## **2.5 Geology, Seismology, and Geotechnical Engineering**

In Section 2.5, “Geology, Seismology, and Geotechnical Engineering,” of the VEGP SSAR, the applicant described geologic, seismic, and geotechnical engineering properties of the VEGP ESP site. SSAR Section 2.5.1, “Basic Geologic and Seismic Information,” presents information on geologic and seismic characteristics of the VEGP site and region surrounding the site. SSAR Section 2.5.2, “Vibratory Ground Motion,” describes the vibratory ground motion assessment for the ESP site through a PSHA and develops the SSE ground motion. SSAR Section 2.5.3, “Surface Faulting,” evaluates the potential for surface tectonic and non-tectonic deformation at the ESP site. SSAR Sections 2.5.4, “Stability of Subsurface Materials and Foundations,” 2.5.5, “Stability of Slopes,” and 2.5.6, “Embankments and Dams,” describe foundation and subsurface material stability at the ESP site.

## **2.5.1 Basic Geologic and Seismic Information**

**Figure 2.5.2-19 - Results of the staff's site response calculations for high-frequency rock motions for the  $10^{-4}$  hazard level. The applicant's mean results are shown for comparison.**

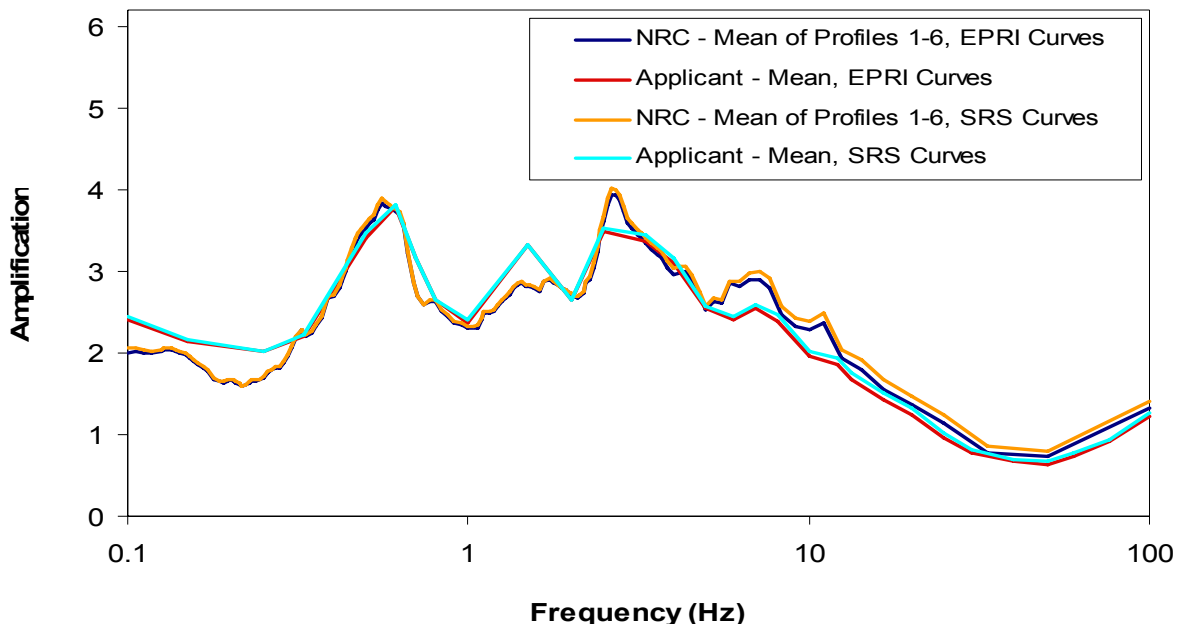
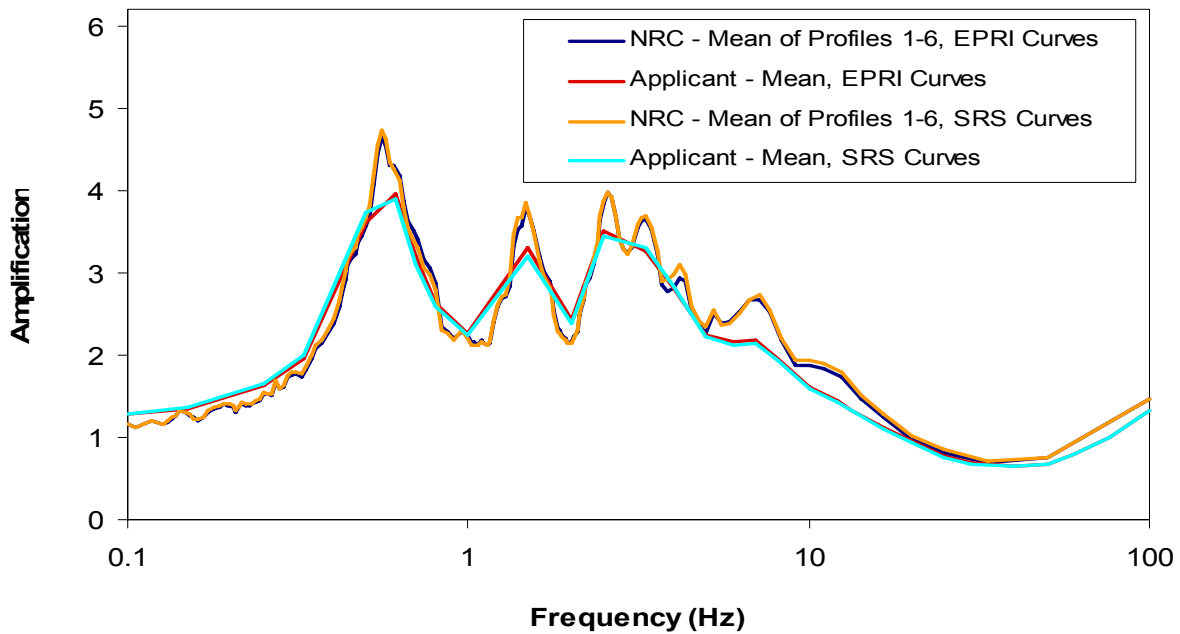
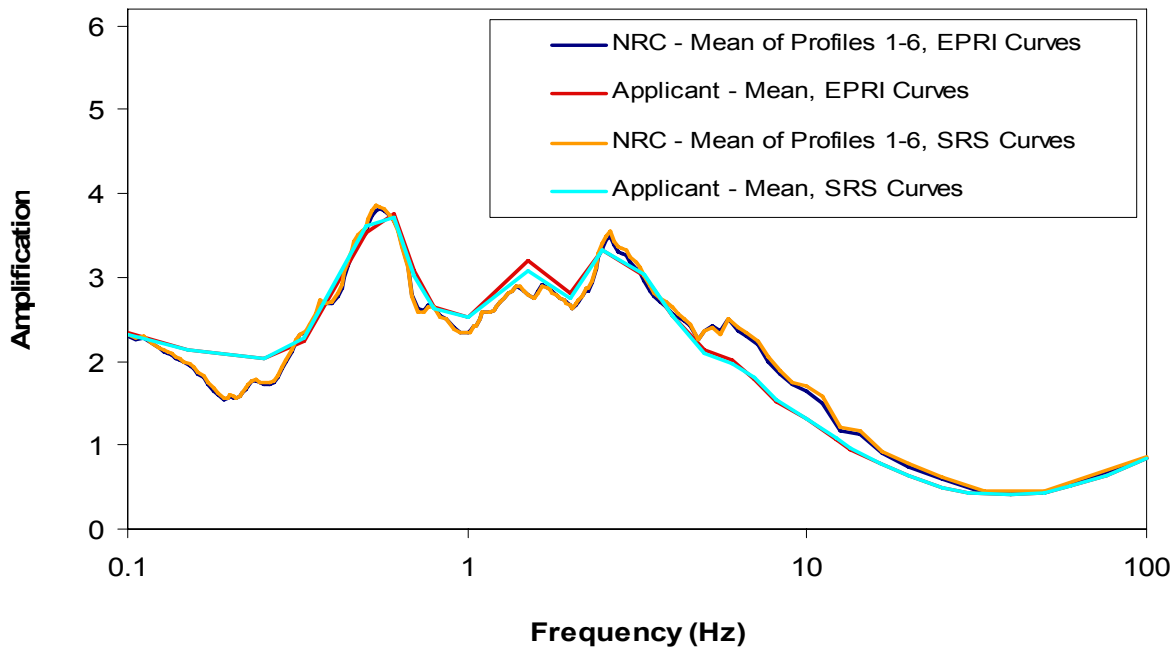
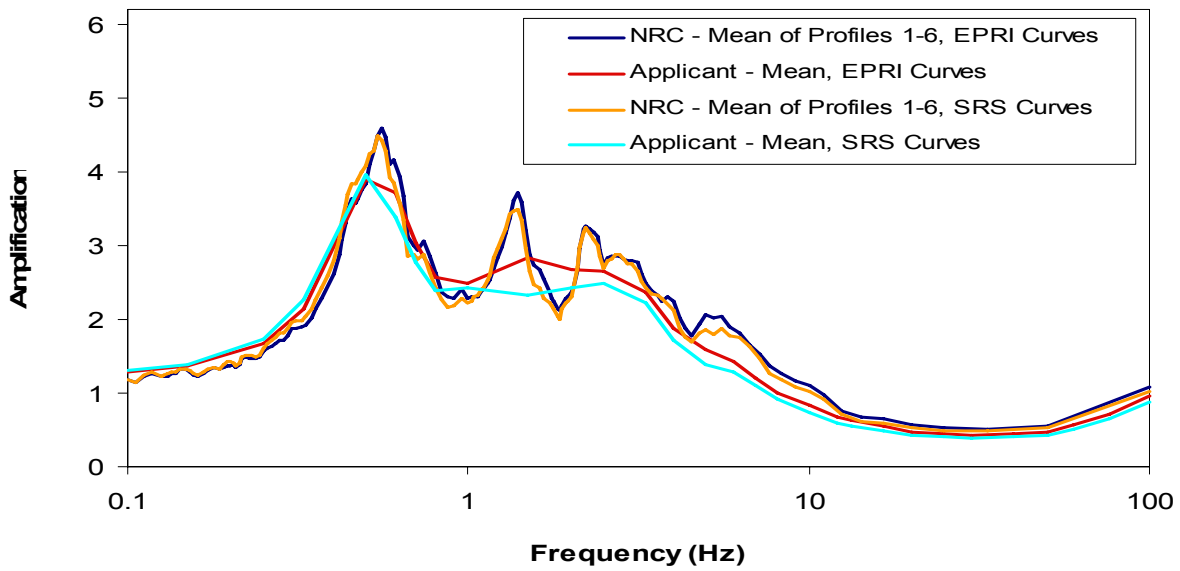
SER Figures 2.5.2-19 to 2.5.2-22 show the mean AFs resulting from the staff's confirmatory site response calculations. Each figure plots the mean results of the six alternative subsurface profiles for both the EPRI and SRS shear modulus and damping curves. SER Figures 2.5.2-19 and 2.5.2-20 show the results corresponding to the  $10^{-4}$  hazard levels for the respective high- and low-frequency input motions, while SER Figures 2.5.2-21 and 2.5.2-22 plot the results corresponding to the  $10^{-5}$  hazard levels for the respective high- and low-frequency input motions. SER Figures 2.5.2-18 to 2.5.2-22 also show the applicant's mean AFs for comparison. The applicant's results are similar overall. For each case, the amplification peaks are very similar, and in all cases, the peaks occur at approximately 0.6 Hz. The differences between the results are likely due to the greater variability that the applicant incorporated into its model through the use of randomized profiles and material properties, as well as the use of multiple time histories. This variability is illustrated in SER Figure 2.5.2-23 (reproduced from SSAR Figure 2.5.2-37). As a result of its analysis, the staff was able to confirm the applicant's overall site response results.
